| DOCKETED | |
|------------------|---|
| Project Title: | 2022 Energy Code Update Rulemaking |
| Document Title: | Statewide CASE Team - Comment on Integrated Pump Refrigerant Economizer Energy Efficiency Review |

Comment on Integrated Pump Refrigerant Economizer Energy Efficiency Review

Figure 1. Pumped Refrigerant Economizer Savings (if Climate Zone-Specific COPs for Energy Equivalent Performance Compared to 2019 Water Economizer Baseline were Adopted) vs. 2022 45-Day Language Water Economizer Baseline

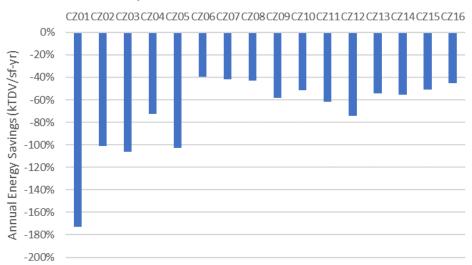
The 45-Day Language for 2022 Title 24, Part 6 shows that outdoor temperature thresholds for air and water economizers are anticipated to increase, thereby reducing energy use of these systems and establishing more efficient code-baseline systems for computer rooms. If the COPs listed in Table 1 were to be adopted as a minimum requirement in 2022 Title 24, Part 6 Section 140.9(a)1C, that code-baseline refrigerant

economizer system would no longer use equivalent energy use to a minimally codecompliant water-cooled chiller plant with water economizing. Instead, the pumped refrigerant economizer system would use significantly more than the other computer room economizer systems minimally-compliant with 2022 Title 24, Part 6 Section 140.9(a)1. Figure 1 shows the incremental annual TDV kBtu energy use per square foot for each climate zone for a pumped refrigerant economizer system in this case.

Therefore, it is important to understand under what conditions a pumped refrigerant economizer system would operate with equivalent energy use to this updated baseline energy use. The analysis above in section 4 was repeated to determine the minimum cooling COP necessary for a pumped refrigerant economizer to perform equivalently to this new baseline.

A minimum full-load COP was calculated for each climate zone in order for the proposed pumped refrigerant economizer cooling energy to be equal to the 2022 45-Day Language energy use for a code-baseline water-cooled chiller plant with water economizing using evaporative cooling towers (chiller cooling + pumps + cooling tower energy). As shown in Table 2, a *pumped refrigerant economizer with a minimum cooling COP of 11.0 and with full economizing at 50°F outdoor dry-bulb* provides equivalent energy use to a water-cooled chiller and water economizer system under 2022 Title 24, Part 6 economizer thresholds for all climate zones, when comparing annual TDV kBtu energy use. A cooling COP of 11.0 equates to a total CRAC net sensible COP of 5.5

Figure 2. Manufacturer Data on Capacity Load Factor and Return Air Temperature's Impacts on Pumped Refrigerant Economizer CRAC

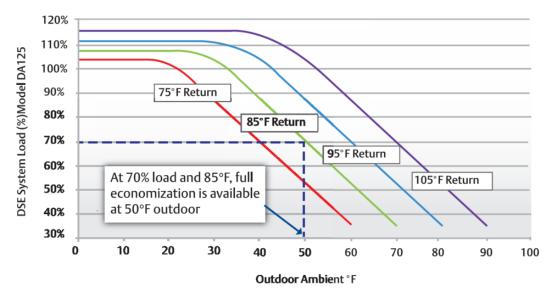
An alternative to the energy code requiring a minimum COP to ensure equivalent energy use for pumped refrigerant economizers could be to increase the minimum outdoor dry-bulb temperature for when full economizing is required, or requiring a combination of increased minimum COP and increased outdoor dry-bulb full economizing temperature. Achieving full refrigerant economizer conditions at higher outdoor temperatures can be achieved by increasing the equipment sizing capacity at design conditions. Increasing the available heat rejection capacity allows pumped refrigerant economizers to operate in full economizing mode at higher outdoor dry-bulb temperatures, thereby reducing energy use. The manufacturer data shown in Figure 2 shows that cooling capacity of the refrigerant economizer drops off as ambient temperatures increase but that the cooling capacity of a refrigerant economizer increases if the return air temperature is higher (as in the case of hot aisle containment already required by Title 24).

The 2022 Title 24, Part 6 Standard allows computer room supply air temperatures up to 80° F when sizing an economizer, so a 95° F return air temperature is achievable. For the sample system in Figure 2, at a 85° F return air temperature and a 50° F outdoor drybulb temperature, the refrigerant economizer capacity is about 70% of the capacity that it can produce at 35° F outdoor drybulb temperature. The chart also shows that one can scale the economizer size up to 1/0.7 = 1.43 of capacity to provide full economizing at 50° F outdoor drybulb temperature. If the same system can be operated at 95° F return air temperature, its capacity is 90% at 50° F outdoor drybulb temperature, and one can scale the economizer size up to 1/0.9 = 1.11 of capacity to provide full economizing at 50° F outdoor drybulb temperature. A similar calculation can be done to show that at 1.6 of capacity a system with a 95° F return temperature or at 1.8 of capacity a system with a 90° F return temperature or at 1.8 of capacity a system with a 90° F return temperature.
